Regular Planning Commission

Consider Approvals Related to Site Plan Review for Sunwood Village; Case of CommonBond Communities

**CITY OF RAMSEY LAND USE APPLICATION
TECHNICAL REVIEW FILE**

DATE	4/3/15	PROJECT ADDRESS	TBD
PROJECT. TITLE	SUNWOOD VILLAGE (SKETCH PLAN, FINAL PLAT, AND SITE PLAN)		
ESCROW #	114596		
DEPARTMENT:	Community Development: Planning Division (Comprehensive Plan and Zoning Code)		
TECHNICAL REVIEWER:	Name: Chris Anderson, City Planner Phone: 763-433-9817 Email: canderson@cityoframsey.com

SITE PLAN
A200

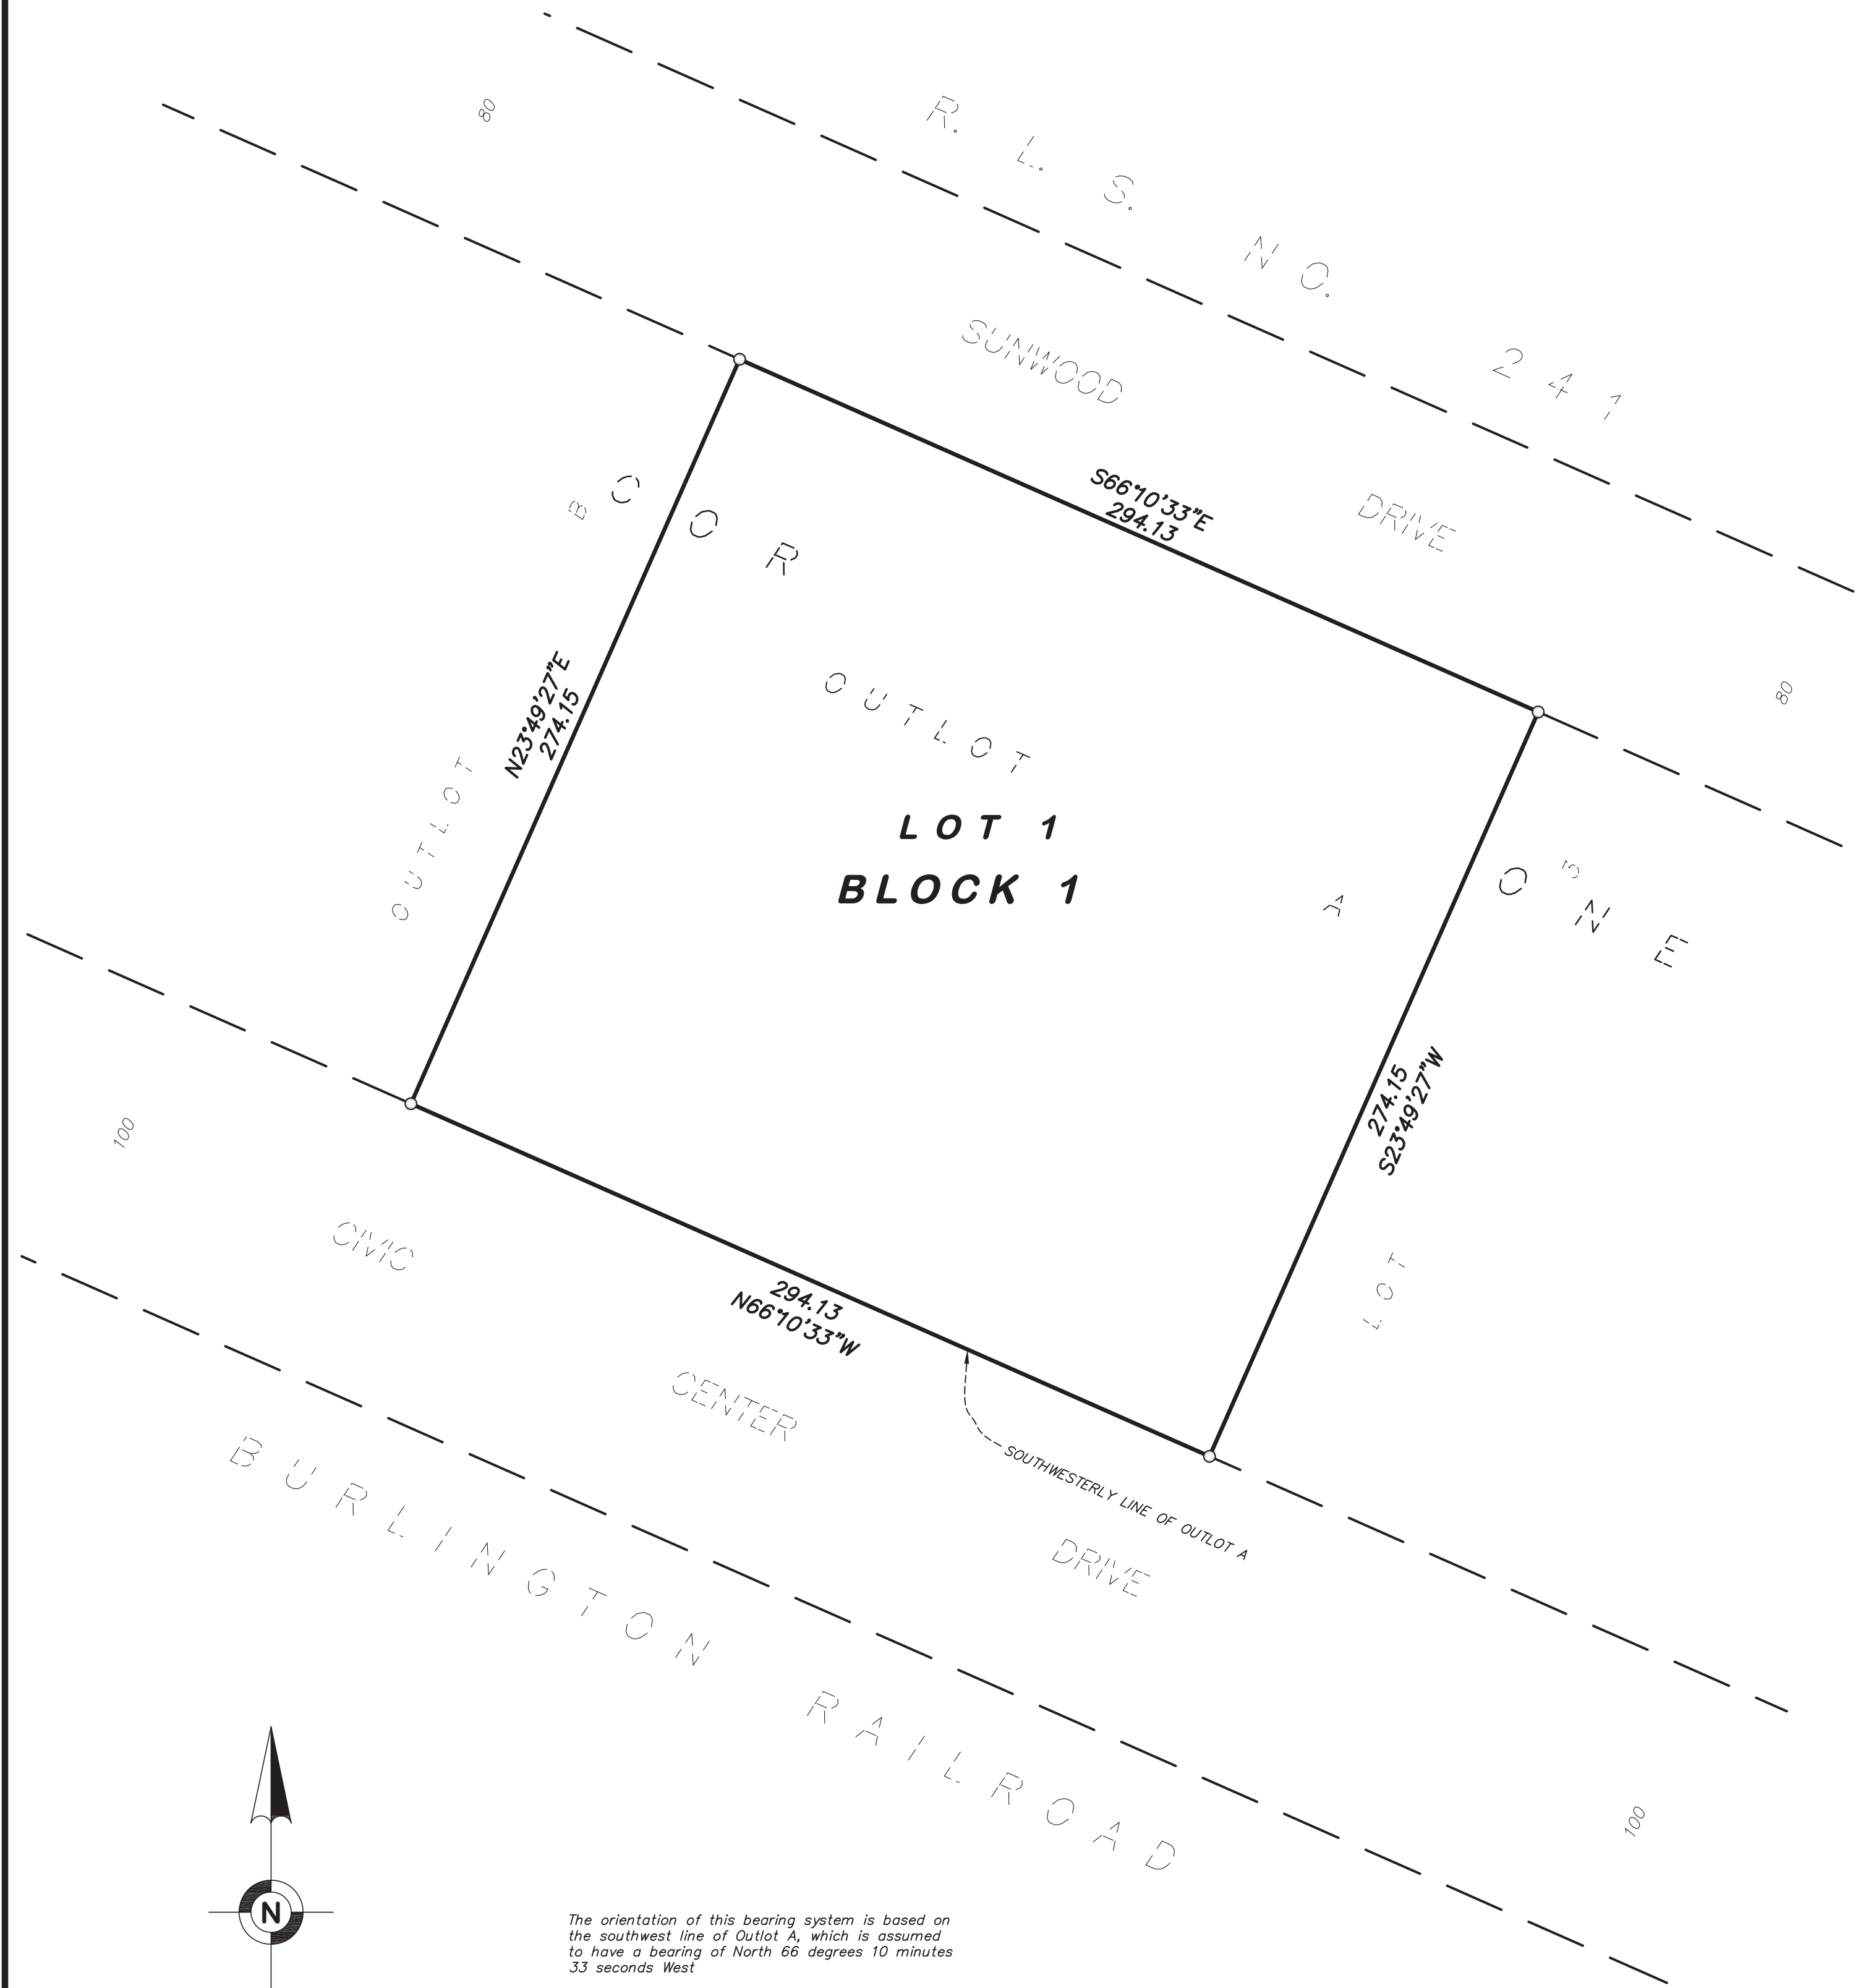
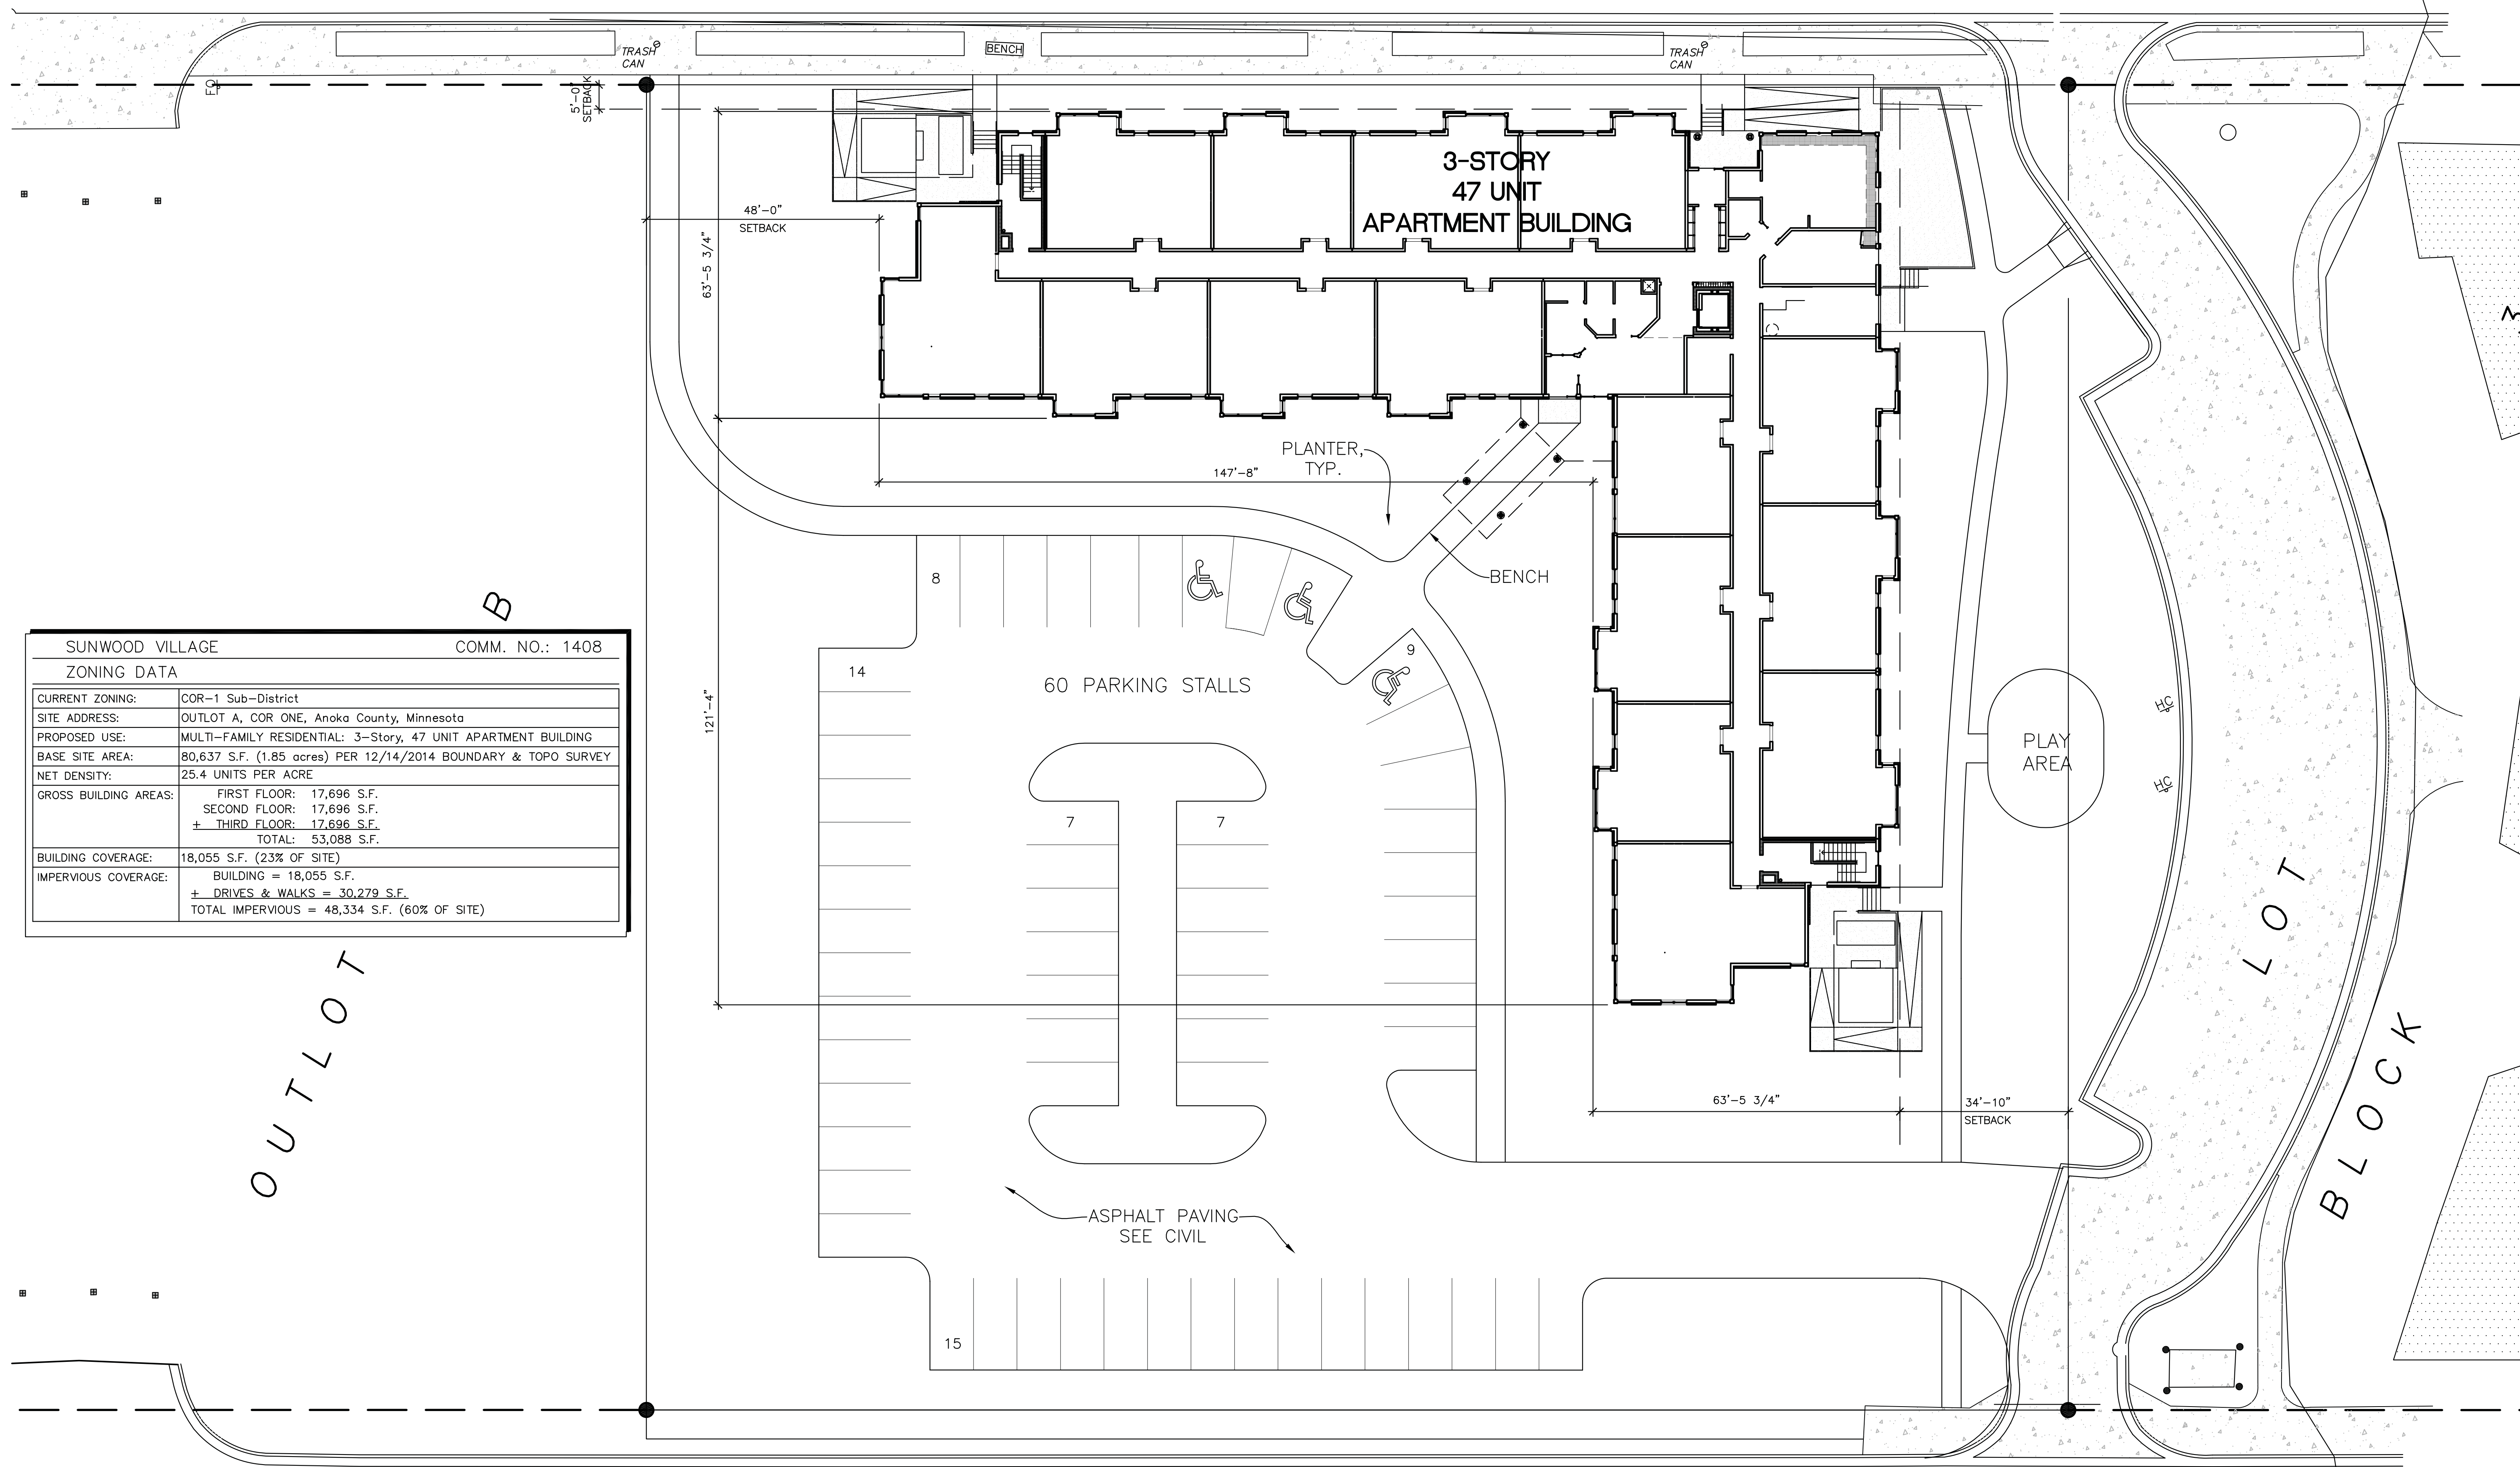
- Add the Floor Area Ratio (FAR) calculation to this sheet.

- Amend to correctly label Veterans Drive.
- Advisory Comment: The internal sidewalk in the northwest portion of the site be shifted to the east, preferably at least ten (10) to fifteen (15) feet, to provide some separation between it and the property line. Otherwise, please provide reasoning for keeping it in the proposed location.

- Sidewalk width along Sunwood Drive should match that of the sidewalk on the east side of the access point (accomplished by extending the existing segment of sidewalk to western boundary of plat). Sidewalk should be widened toward the building, which will result in the building shifting south slightly. Please provide a hand sketch of the revised sidewalk prior to revising plan sheets so that City Staff can verify its placement.
